4. Electrification Technologies

Project Feedback

2019 ANNUAL MERIT REVIEW, VEHICLE TECHNOLOGIES OFFICE

Figure 4-10 – Presentation Number: elt188 Presentation Title: Bi-Directional Wireless Power Flow for Medium-Duty Vehicle-to-Grid Connectivity Principal Investigator: Steven Sokolsky (CALSTART)

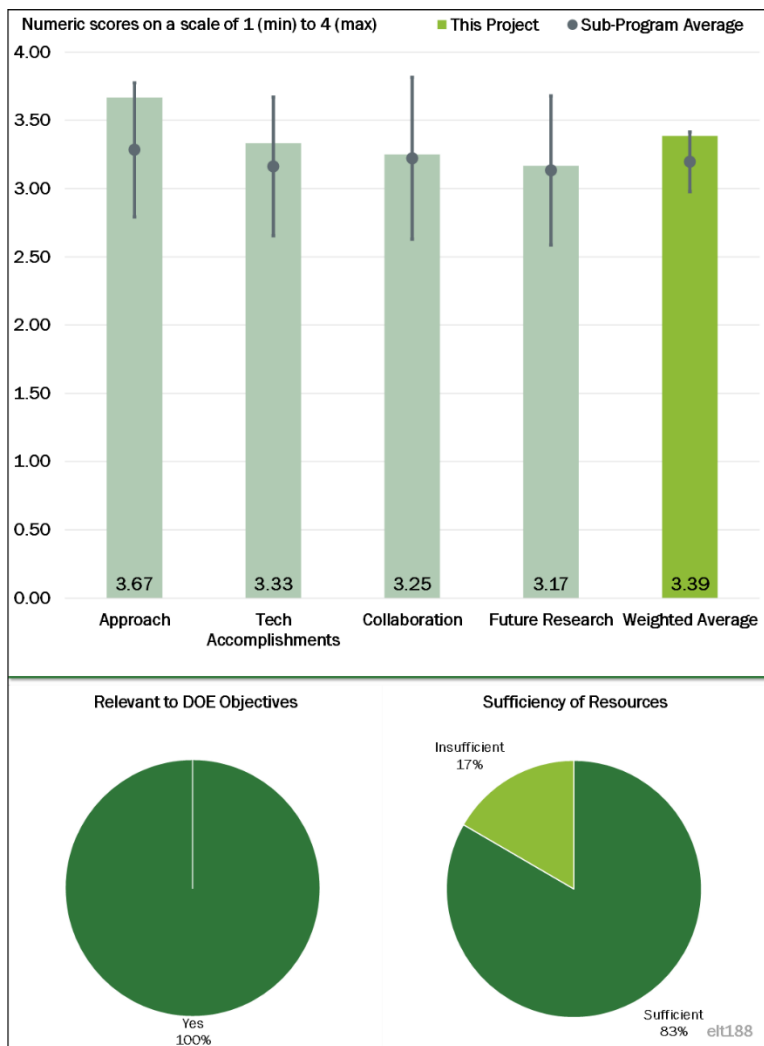
Reviewer 5:
 The reviewer commented that the project had a well thought-out approach to address the barriers of wireless power transfer with large air gap, at a high power level, and with bidirectional power flow.

The reviewer said when the principal investigator was asked a question about why such a low transfer rate of 20 KW-hr, the stated answer was because it was all the client needed. It should have been decided based on an analysis of what the collaboration partner would get best value from. It was not clear whether the partner was ever consulted on this matter. The reviewer noted that the build and setup of a demo after the vehicle type changed is the principle cause for delay.

The reviewer commented that the project team has made good progress in designing and simulating the wireless power transfer system. The hardware development seems to be delayed. The primary and secondary power stages have been fabricated, but not tested yet, so the reviewer cannot comment on the performance or whether it is meeting the target efficiencies.

The reviewer reported that extensive design work has been completed, coupling coils have been built, stuff has been measured, and a lot of analysis has been done. The reviewer inquired about what the analysis indicated to the project team. Additionally, for non-specialists, this reviewer requested that the graphics include an explanation of the information presented.

Figure 4-11 – Presentation Number: elt189 Presentation Title: Electric Truck with Range-Extending Engine (ETREE) Principal Investigator: John Kresse (Cummins)

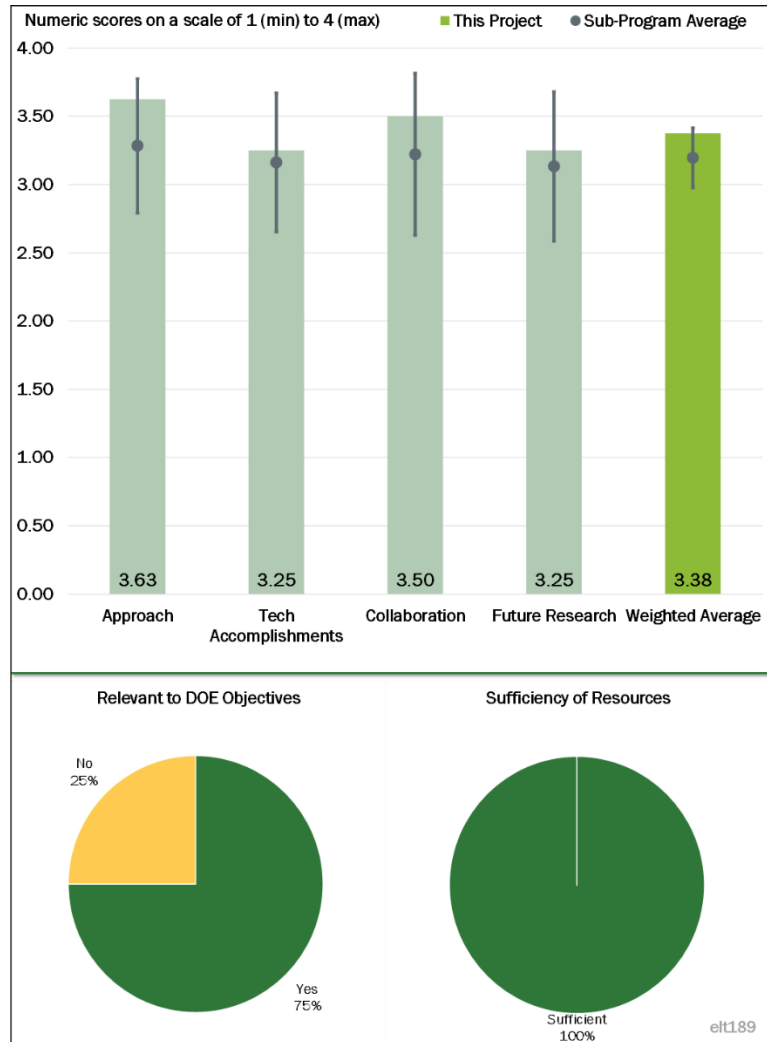
Reviewer 4:
 This reviewer stated that using a 4.5-liter diesel engine with selective catalytic reduction (SCR) to power a generator seems counter-productive.

The reviewer said the project results show the decision to develop a new battery pack was successful as indicated by successful operation for track testing. Outstanding results showing correlation between track test results and National Renewable Energy Laboratory (NREL) duty-cycle modeling results. The technical accomplishments score could be higher if more on-road operation (by fleet partners) was accomplished. The milestone / schedule shows the project is a little behind the plan. A significant amount of time (approximately one year) for on-road operation across a wide range of operating conditions (temperature, driver variability, load variation) will provide results and validation to demonstrate the success of the project.
